**COMMANDER 114 SERIES
SERVICE PUBLICATIONS**

The following is a numerical list of all active Service Bulletins.

SERVICE BULLETIN NO. SB-114-1

AILERON CONTROL CHAIN REROUTING

Figure 1. (Sheet 1 of 2)

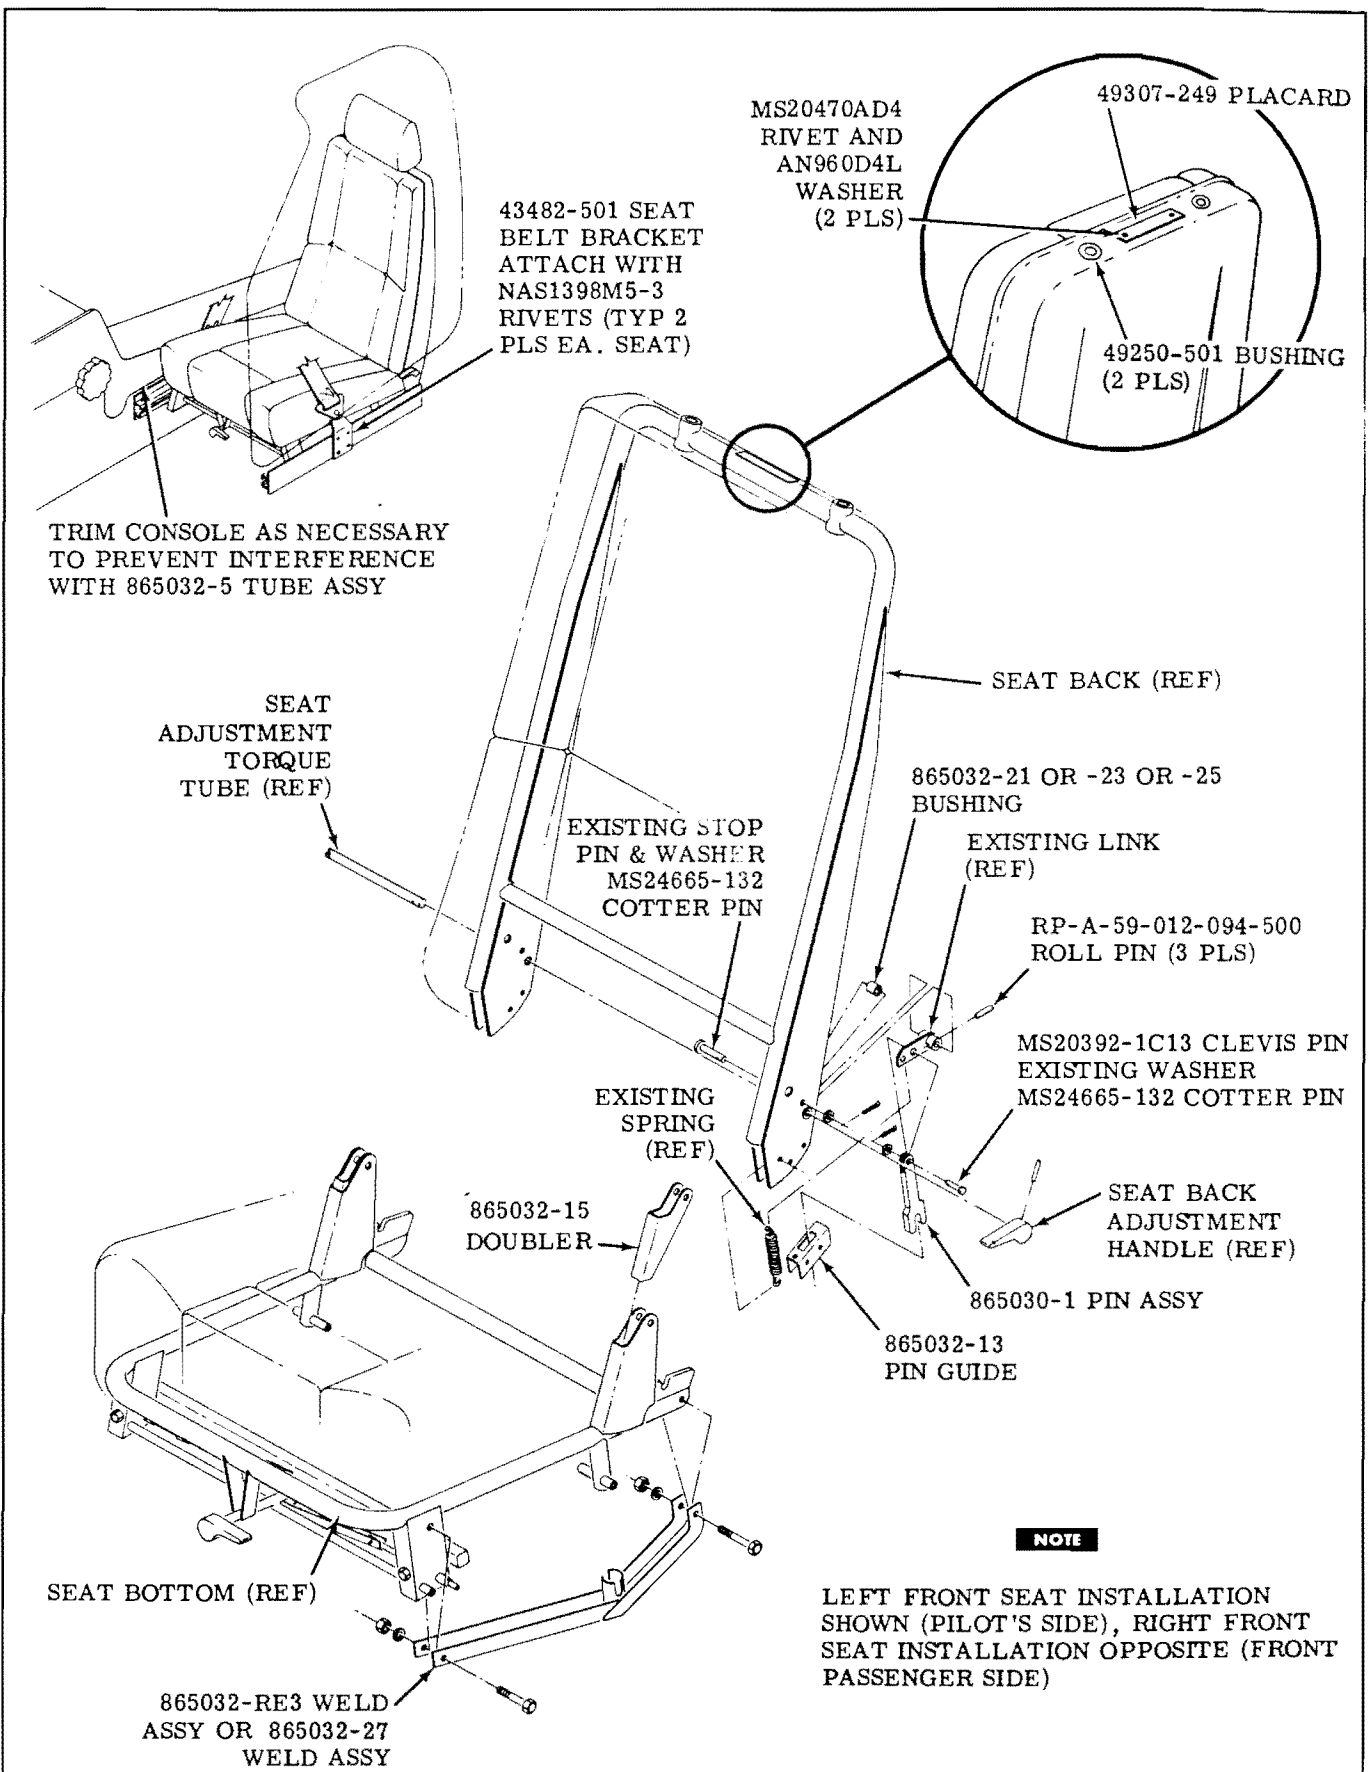
- o. Install 865032-21 or -23 or -25 bushing as required on existing stop pin to prevent 865030-1 pin assembly from passing over forward ratchet stop (see Figure 1., Sheet 1 of 2).

- p. Locate, drill and install 49307-249 placard on left and right seat back shrouds (see Figure 1., Sheet 1 of 2).
 - q. Reinstall existing seat back shroud on seat back using existing hardware.

- r. Install new 49250-501 headrest bushing (2 places) on each seat back and reinstall seat headrest (see Figure 1., Sheet 1 of 2).
 - s. Reinstall existing seat back adjustment handle on torque tube (see Figure 1., Sheet 1 of 2).

- 5. Remove pilot and front seat passenger seat belts from airplane.
- 6. Remove and discard existing seat belt attach bracket (4 places) (see Figure 1., Sheet 1 of 2).
- 7. Install new 43482-501 seat belt bracket (4 places) using NAS1398M5-3 rivet (4 places) (see Figure 1., Sheet 1 of 2).
- 8. Reinstall existing seat belts using existing hardware.
- 9. Reinstall existing carpet around seat tracks with 3642A Tuf-Grip or 3M EC 1300 cement or equivalent.
- 10. Install pilot seat and front passenger seat in airplane.
- 11. Trim interior console cover as necessary to prevent interference with 865032-5 tube assembly during forward and aft movement of seats.
- 12. Reinstall existing interior console cover.
- 13. Fill out and mail Compliance Card.

Figure 1. (Sheet 2 of 2)

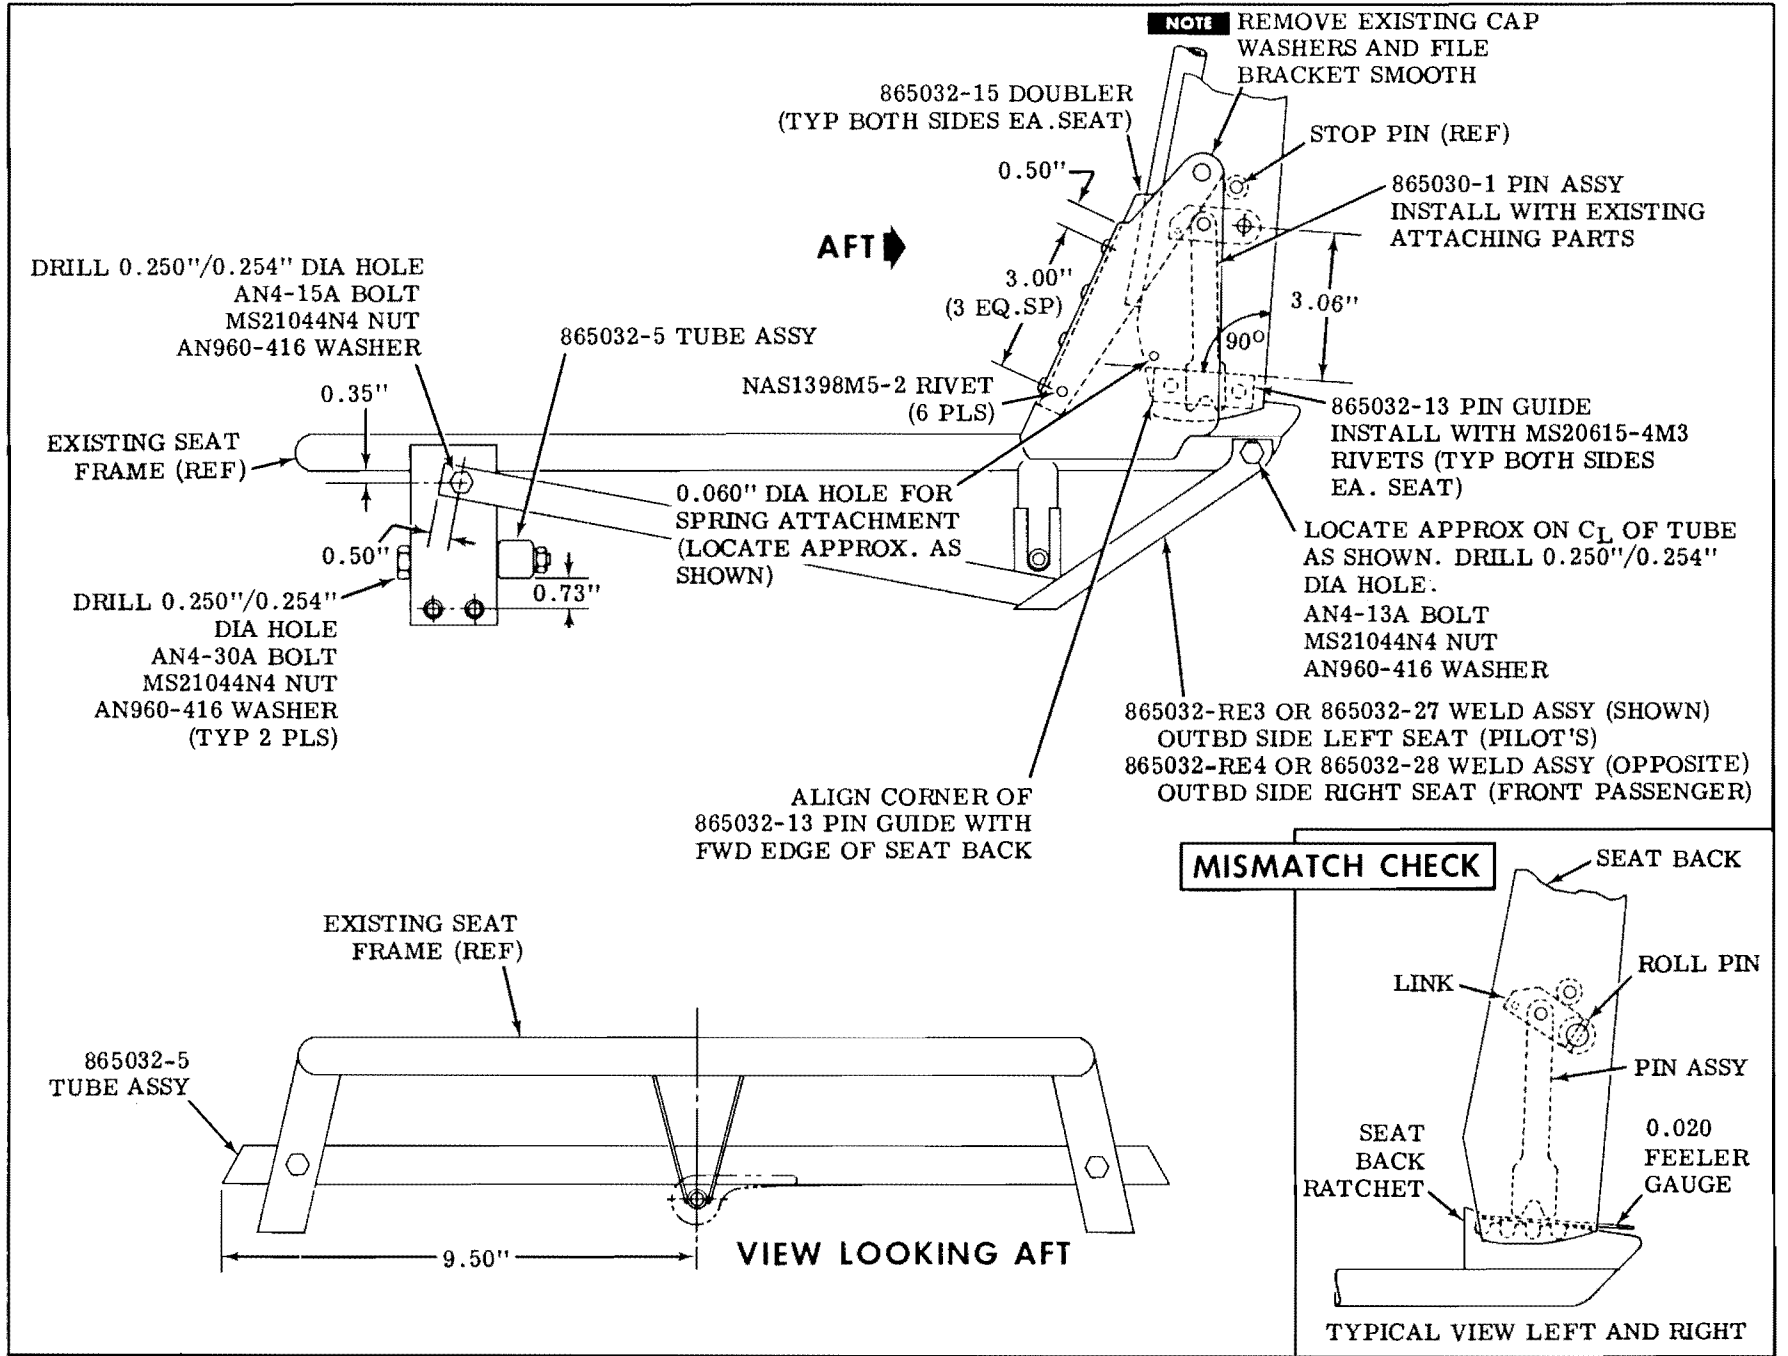
- g. Install 865030-1 pin assembly and existing seat back adjustment torque tube, link and spring in left and right side of both seat backs. Drill a 0.060 inch diameter spring attach hole in seat bracket (see Figure 1., Sheet 2 of 2).

- h. Locate, drill and install 865032-13 pin guide on seat back with MS20615-4M3 rivet (4 places) (see Figure 1., Sheet 2 of 2).
- i. Locate, drill and install 865032-15 doubler (2 places) on each seat bottom with NAS1398M5-2 rivet (6 places) (see Figure 1., Sheet 2 of 2).

- j. Locate, drill and install 865032-5 tube assembly on seat bottom (see Figure 1., Sheet 2 of 2).
- k. Locate, drill and install 865032-RE3 or 865032-27 weld assembly on outboard side of pilot seat bottom and 865032-RE4 or 865032-28 weld assembly on outboard side of forward passenger seat bottom (see Figure 1., Sheet 2 of 2).

- l. Reinstall seat back on seat bottom using existing hardware.
- m. Check for mismatch between left and right pin assemblies by placing a 0.020 inch feeler gauge between pin assembly and teeth of ratchet on both sides of seat back and then measuring gap between pin assembly and feeler gauge on high side (see Figure 1., Sheet 2 of 2).

Mismatch shall not exceed 0.065 inch.

Figure 1.

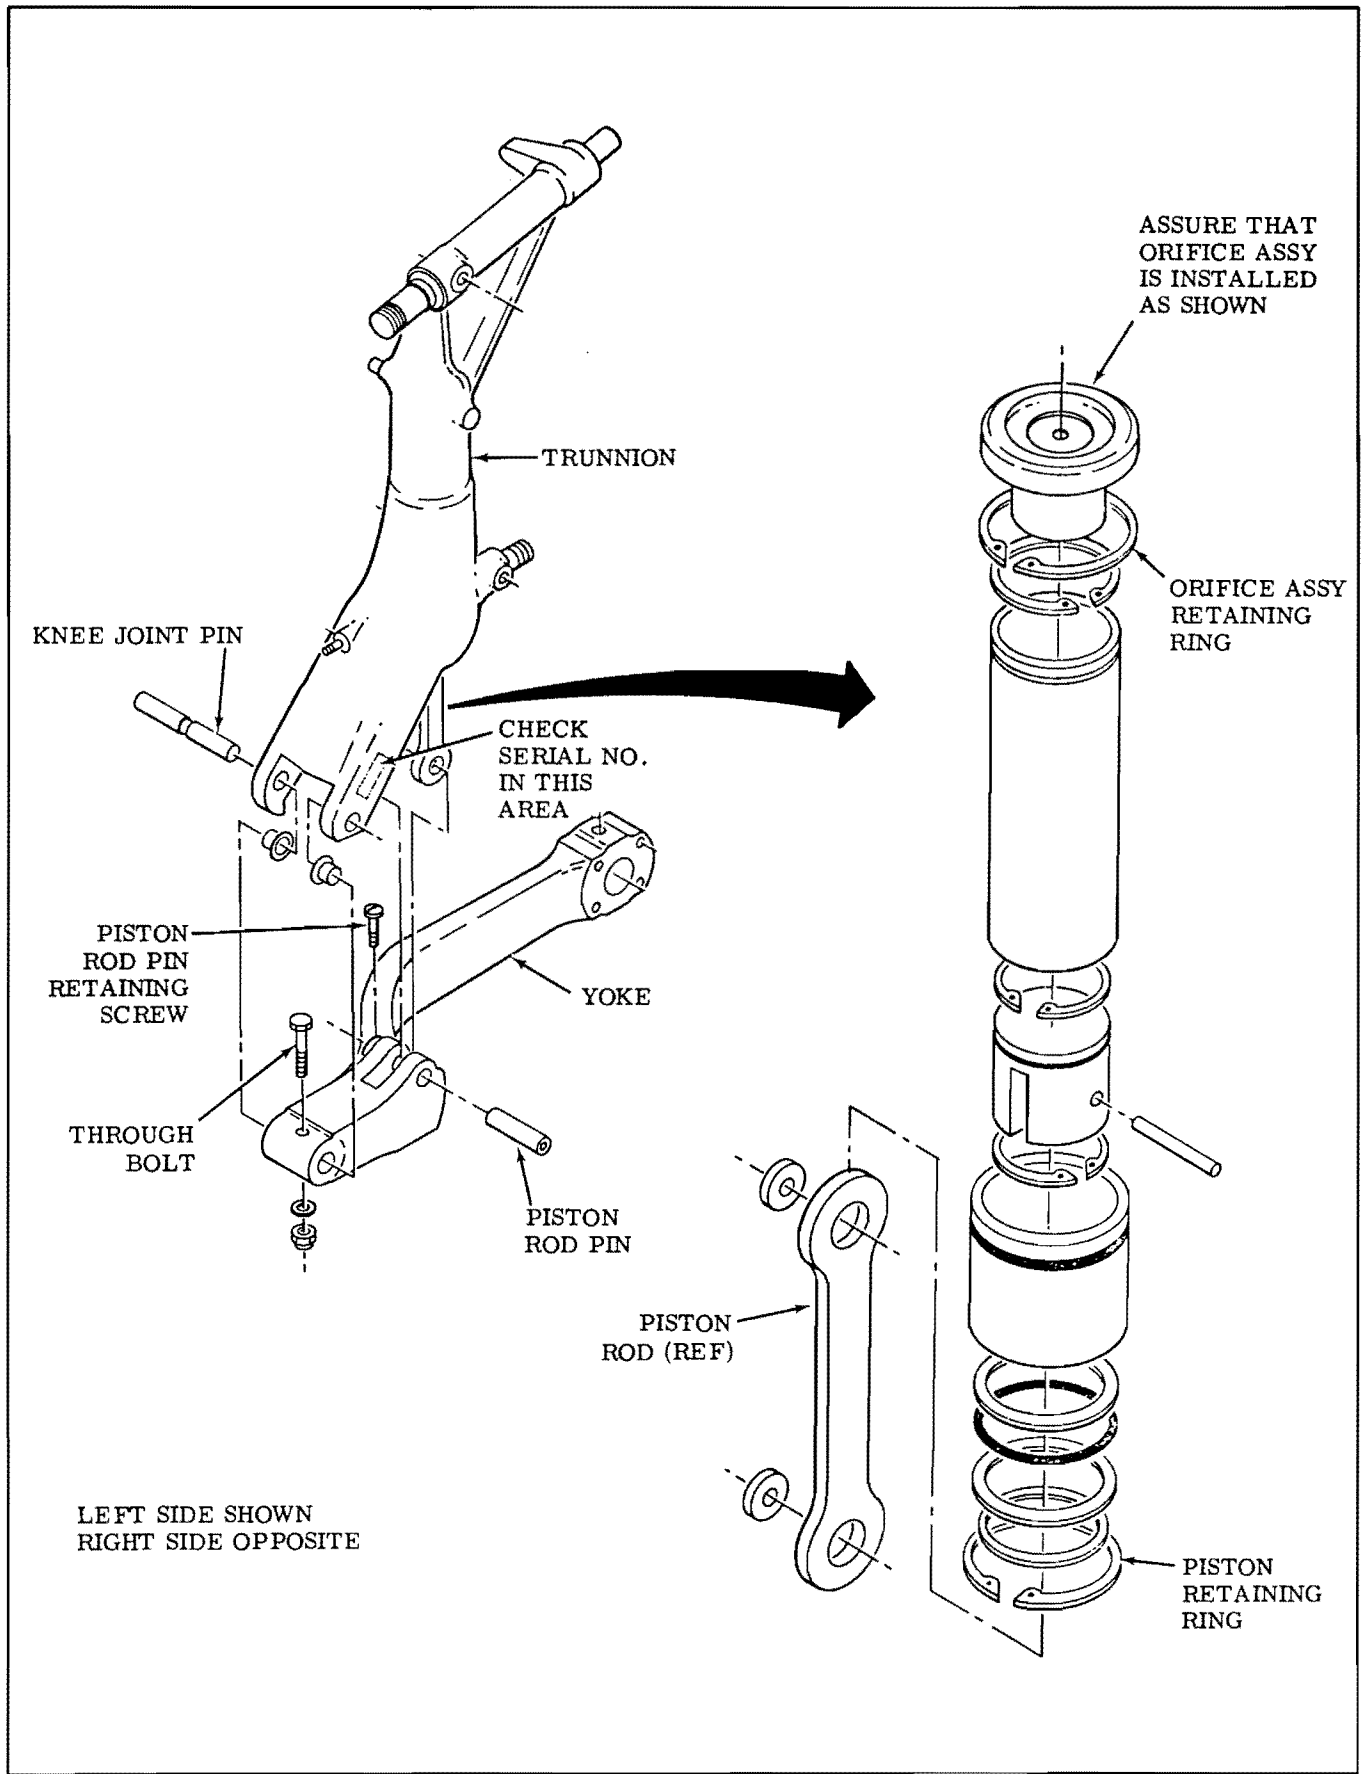
1. On left and right main landing gears, check serial number which is electric etched on the left side of the trunnion assembly (see Figure 1.).
2. If the serial number is LMC 077 and over, disregard this Service Bulletin.
3. If the serial number is LMC 001 thru LMC 076, proceed to step 4.

13. Remove the orifice assembly retaining ring, inside the upper area of the strut, and the orifice assembly.
14. Reinstall the existing orifice assembly correctly in the strut using existing retaining ring (see Figure 1.).

Figure 1.

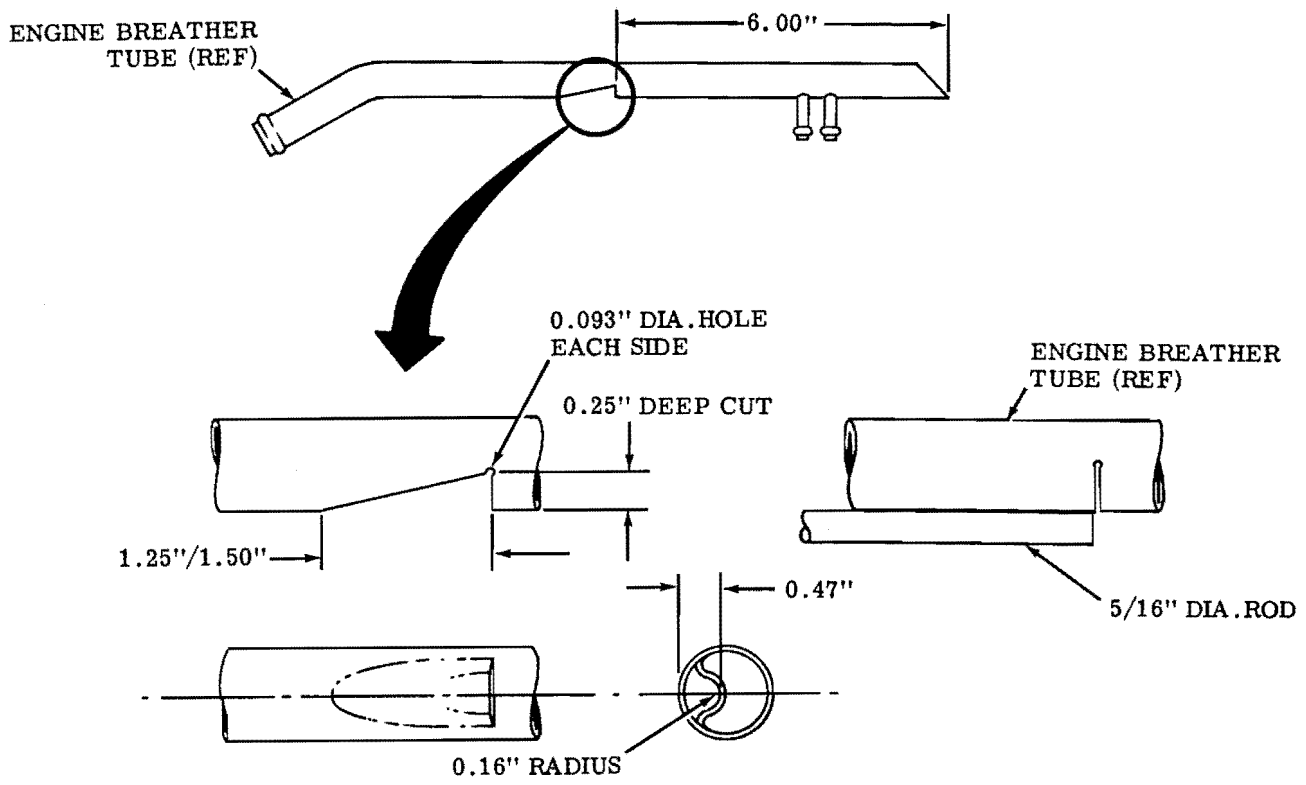
1. Remove upper engine cowling.
2. Open lower left engine cowl flap to gain access to engine breather tube lower attaching bolts.
3. Remove bolts attaching engine breather tube to firewall and remove breather tube from airplane.
4. Fabricate a cardboard template as shown in Figure 1.
5. Place template over forward side of engine breather tube and scribe marks for stop drill holes.
6. Drill 0.093-inch diameter hole on both sides of engine breather tube (see Figure 1.).
7. Cut a slit in the engine breather tube to dimensions shown in Figure 1.
8. Place a 5/16-inch diameter rod on engine breather tube above slit and form vent hole in breather tube, to dimensions shown in Figure 1., by hitting rod with hammer.

NOTE
DIAMETER OF
BREATHER TUBE
IS 1.00" O.D.

Figure 1.

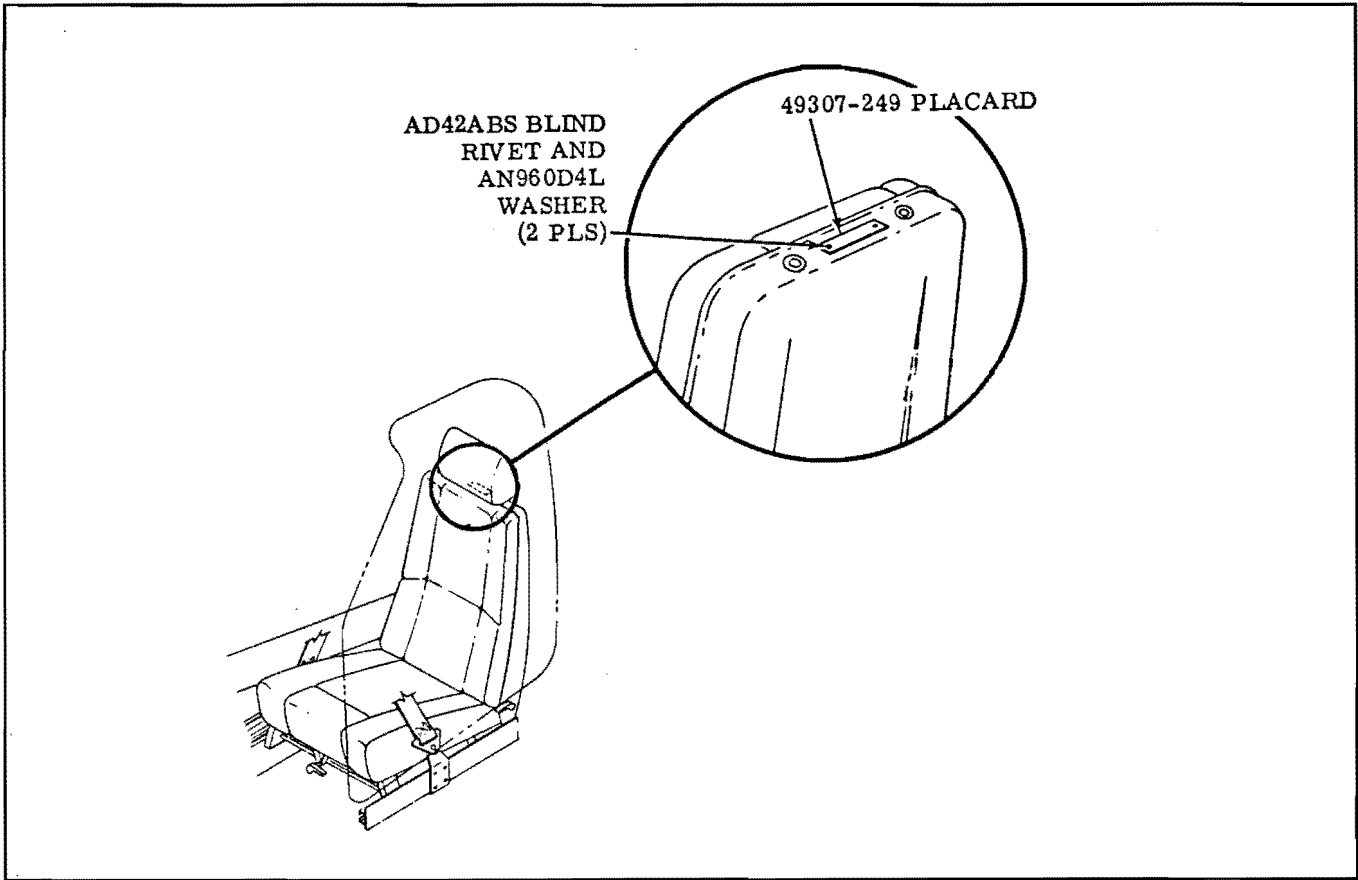
1. Remove pilot and front passenger seat headrests.
2. Locate, drill and install 49307-249 placard on pilot and front passenger seatbacks with AD42ABS blind rivet (2 places) and AN960D4L washer (2 places) (see Figure 1.).
